TECHNICAL BULLETIN	
	July 2002 TB 1993
Mfg:	GM
Model:	C-SERIES
Liter:	6.0L
V I N:	U
Year:	99-06

Revised Cylinder Head Installation Procedure For
1999-2002 GM 4.8, 5.3 & 6.0L VIN V, T, Z, S, U & N Engines

Bulletin Diagram: FIGURE 1, CYLINDER HEAD BOLT TORQUE SEQUENCE - CYLINDER HEAD

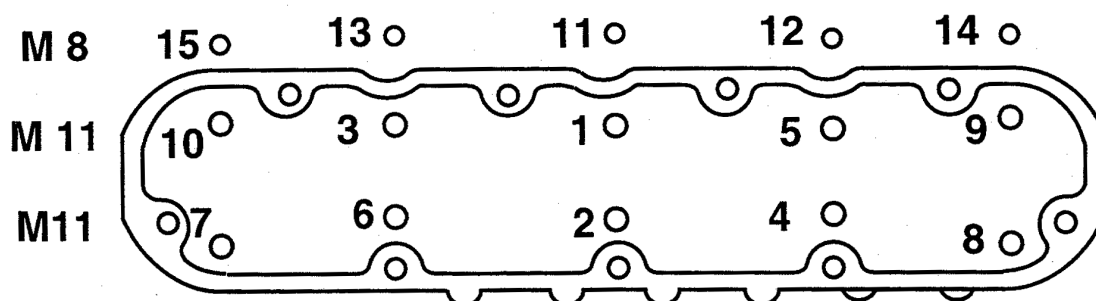
Previously, it was published in service information that it was acceptable to reuse the 8 mm cylinder head bolts. It is now recommended all cylinder head bolts should be replaced at the time of cylinder head installation. The new 11 mm bolts come with a pre-applied sealer and lubricant and no other sealant should be used on them.

Note: Do not re-use either the 8mm or 11mm head bolts.

1. Tighten new 11 mm bolts (1-10) in sequence to 22 ft/lbs (30 Nm).
2. Rotate those bolts (1-10) in sequence an additional 90° turn using a torque angle meter.
3. Rotate only bolts 1-8 in sequence an additional 90° turn using a torque angle meter.
4. Rotate remaining 11 mm bolts 9 & 10 in sequence an additional 50° turn using a torque angle meter.
5. Apply a .200" (5 mm) bead of locking compound (GM P/N 12345382 or equivalent) to the new 8 mm bolt threads, and tighten bolts (11-15) in sequence to 22 ft/lbs (30 Nm).
